PCN: V16-006-E47540-MAA

Product Change Notice

Description and Extent of Change:
MPO port plug change of transceiver modules.

Current MPO Port Plug + CXP Module

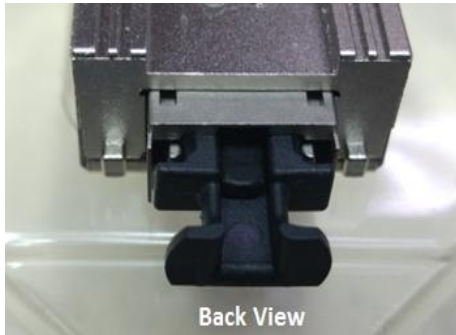
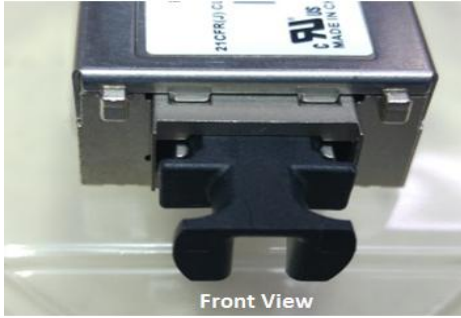
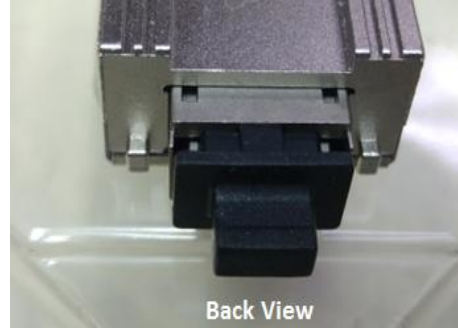
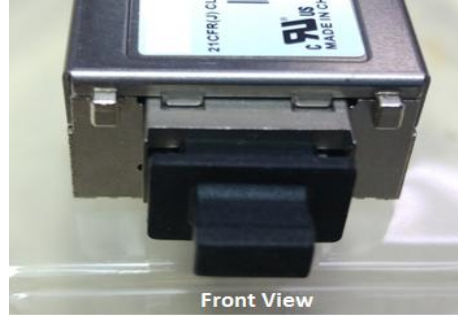
Standardization to existing port plugs to provide greater assurance of supply.

New MPO Port Plug + CXP Module
